NCFMP and NCDOT MOA Project Review

Project TIP:	R-2527[61000_303_L]	Stream Name:	Lick Fork
Sch Let Date:	11/29/2019	Route Number:	NC 24/27
CLOMR Case Number:	N/A	Road Name on Panel:	NC 24/27
Municipality:	N/A	Effective FIS Date:	6/16/2009
County:	Montgomery	Panel Number:	7506
CID Number:	370336	Panel Effective Date:	1/2/2008
Project Engineer:	Brandon Barham	Bounding Stations:	Station 403/396
Project Reviewer:	Matthew Dudley, PE

Deck/Roadway Data Editor

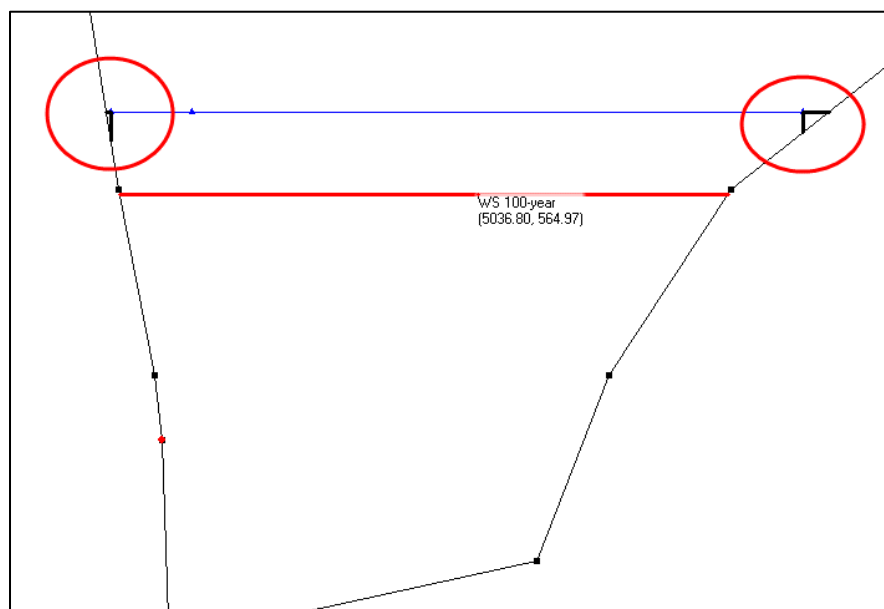
1. In the Revised plan, please resolve the negative surcharge at RS 40076. All surcharges within the project area should be positive and less than one foot. **After multiple attempts to eliminate the negative surcharge, it could not be done. According to the Riverine Hydrologic & Hydraulic Engineering Guideless and Standards, with reasonable effort, the accepted range is between -0.09 and 1.04 feet. This has been added to the narrative.**
Verified. No action needed.
2. For structures in the project area, verify that the Max Submergence is 0.98. In the Corrected Effective plan, the structure at RS 39915 does not have a Max Submergence value. **A max submergence of 0.98 has been added in the corrected model.**
Verified. No action needed.

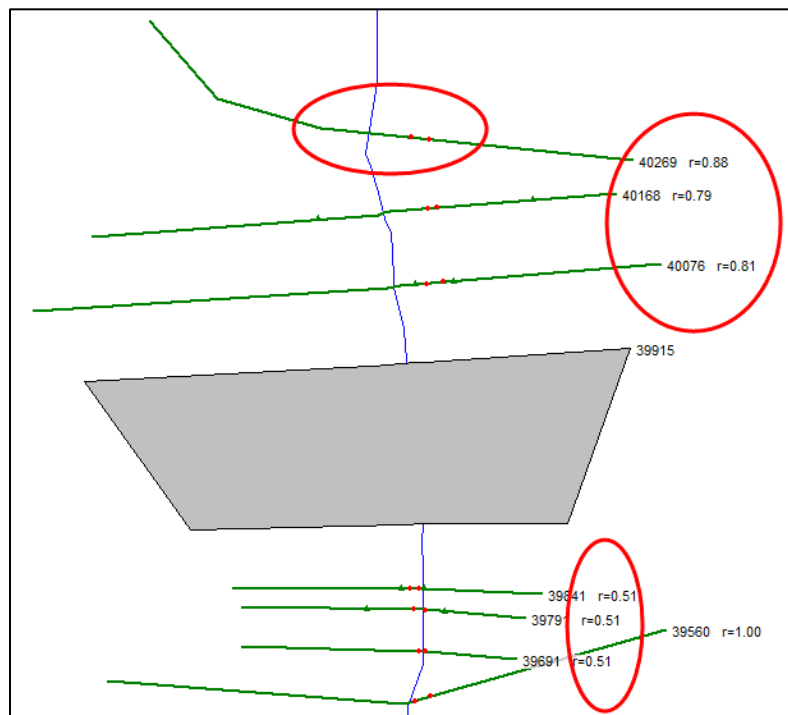
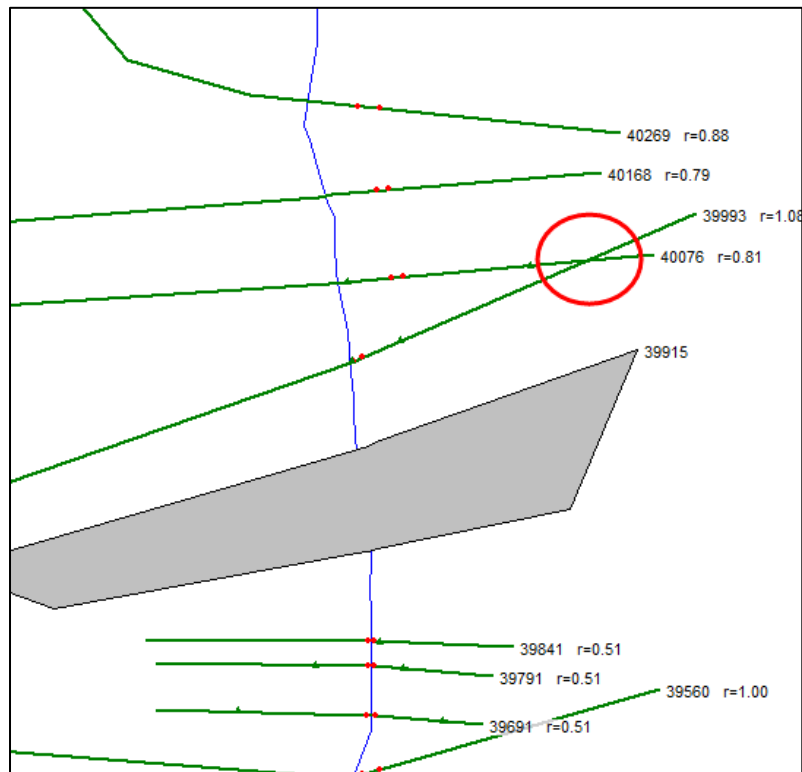
7. Please verify that the sections were input appropriately in the Corrected Effective and Revised plans such that the cutline length in the geometric data matches the cross-section length (r value of 1.0). Do not worry about effective cross sections outside of the project area, but all newly added sections should be inserted so that the cutline length matches the cross-section length. **Cutline length now matches the cross-section length.**

Verified. No action needed.

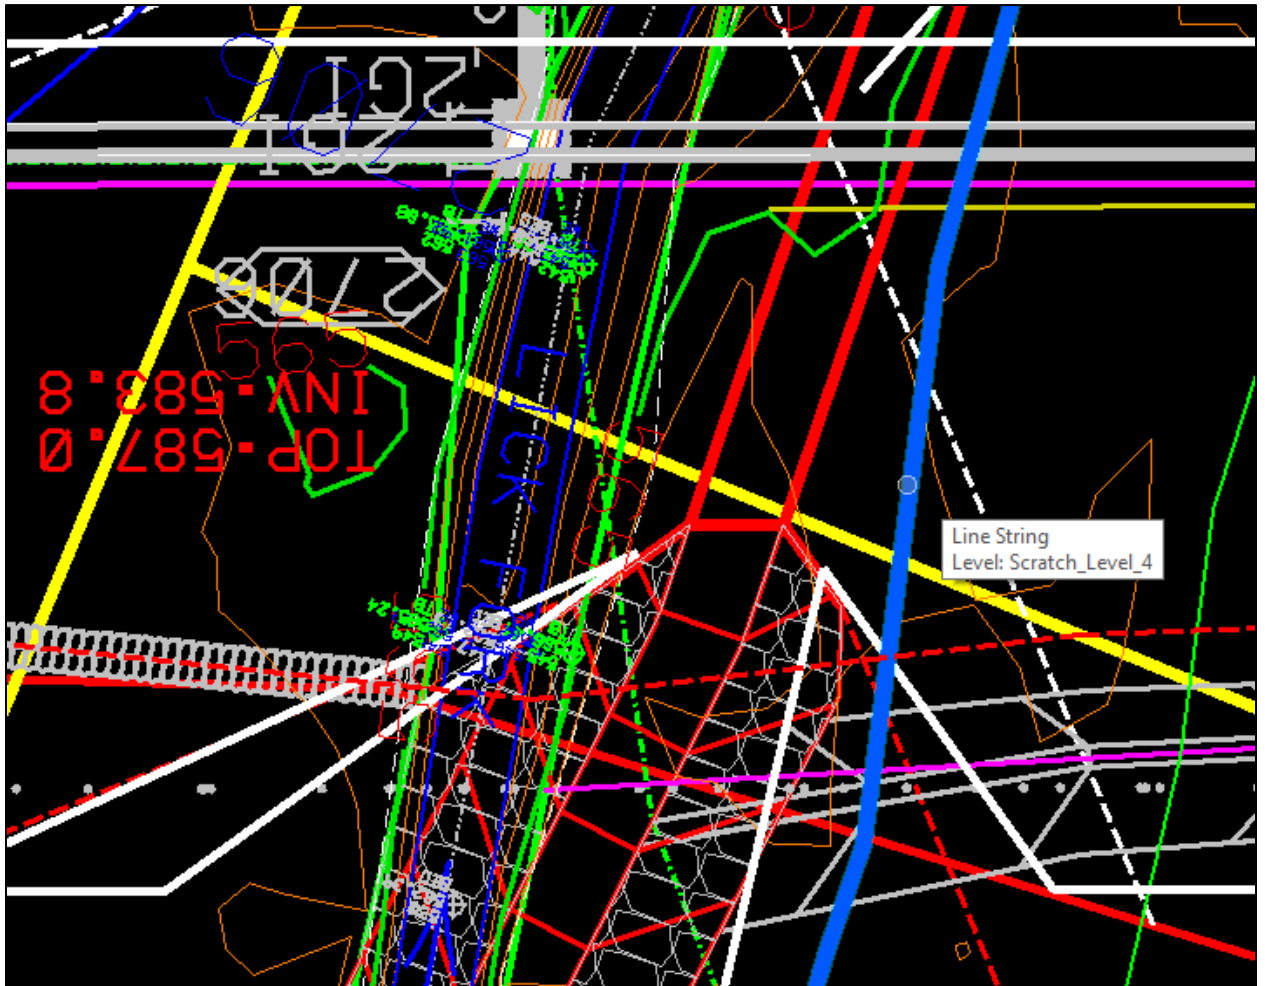
9. The narrative suggests the ineffective stations were determined spatially using contraction and expansion lines drawn on the work map. However, when the reviewer measured the location of the ineffective stations on the work map, several stations do not match the ineffective stations within the model. See tables below. Please verify the ineffective stations so the contraction ratio is 1:1 and expansion ratio is in the range from 1:1 to 1:4. **There may have been a discrepancy on which stream centerline was used to determine ineffective stations. The workmap has been updated to make sure that it is clear as to which stream centerline should be used. The centerline is shown in blue and on "Scratch level 4." It should also be noted that some of the cross-section centerline stations were not based on 5000. Notes have been added to the narrative to clarify what the centerline station should be for each cross-section. When using the correct centerline station and "Scratch Level 4" as the correct stream centerline the ineffective areas listed in both the corrective effective and revised models match what is shown in the workmap. A contraction and expansion ration of 1:1 was used as noted in the narrative.**

In addition, the cross-section lengths in the model do not match the measured cross-section lengths on the workmap. (See table below). In order to ensure ineffective stations are placed at appropriate locations within the model, the cross-section lengths must agree. Our review measures the distance from the end of the cross-section to where the ineffective

contraction/expansion line intersects the cross-section. This distance should agree with the ineffective placement in the model.

RS 3993 was updated in the Hec-Ras Model to be consistent with what is drawn in the workmap for both the CE model. The XS length in the Workmap and Hec-Ras Model are both 932.3. The ineffective areas match between the workmap (measured) and what is drawn in the Hec-Ras Model when measured from the stream centerline station (set at 4977.9 as noted in narrative)

RS 40076 was updated in the workmap and now matches the XS length that is included in Hec-Ras. Both the CE and REV models have a length of 950.8. The ineffective areas match between the workmap (measured) and what is drawn in the Hec-Ras Model when measured from the stream centerline station (set at station 4963 as noted in narrative).

RS 39841 was updated in the workmap and Hec-Ras so that the XSs lengths match in both the workmap and Hec-Ras Model for both CE and REV plans. The length is 743.7'. The ineffective areas match between the workmap (measured) and what is drawn in the Hec-Ras model when measured from the stream centerline station (set at station 5015.7 as noted in narrative).
